**TOWNSHIP OF WAYNE
WATER AND SEWER DIVISION**

RE: PB-2023-003 1195 & 1207 Hamburg Turnpike, LLC
1195 Hamburg Turnpike
Block: 2711 Lot: 106

I have reviewed the site plan titled "Preliminary/Final Major Site Plan 1195-1207 Hamburg Turnpike", Revision No. 7, dated 09/05/2023, prepared by Page Consultants Inc., and I have the following comments:

GRADING AND UTILITY PLAN

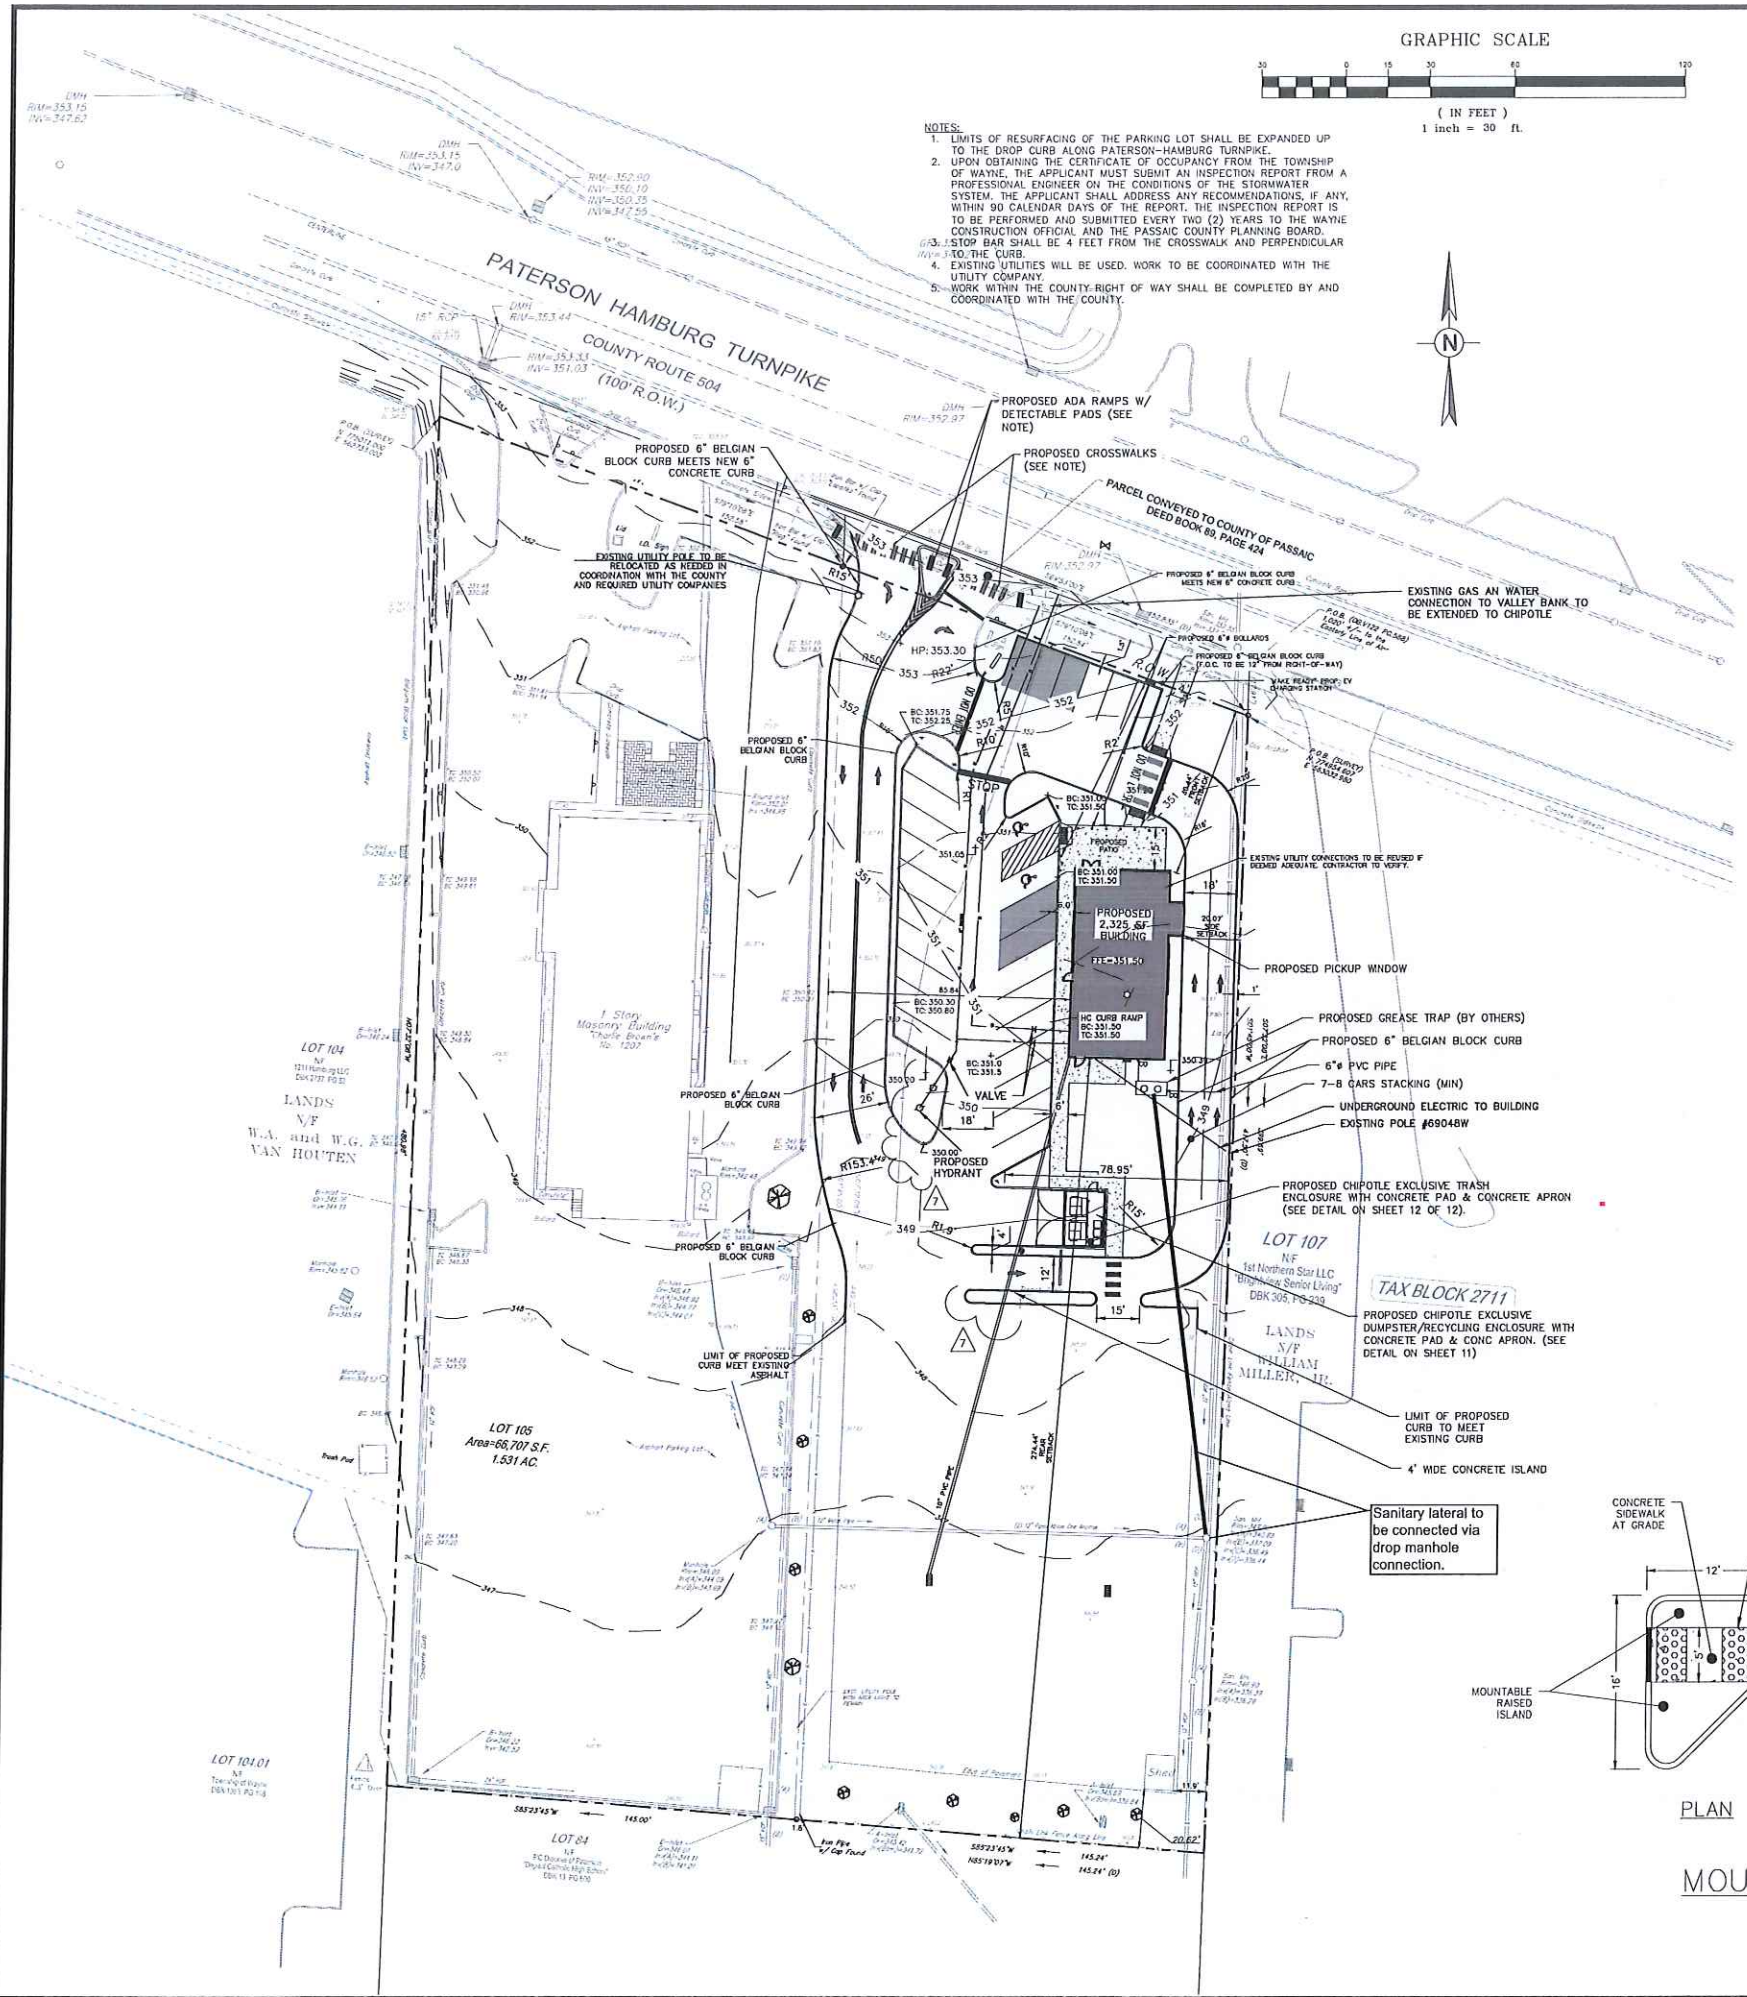
- Gate valve relocated closer to hydrant on the concrete pad.

- After further review, a field inspection and the current flow load in the main a saddle tap is not an option and the new sanitary lateral is to be connected via a drop manhole. I attached the drawing with the recommended lateral path. A Township detail for this type of connection will need to be added to the plans.
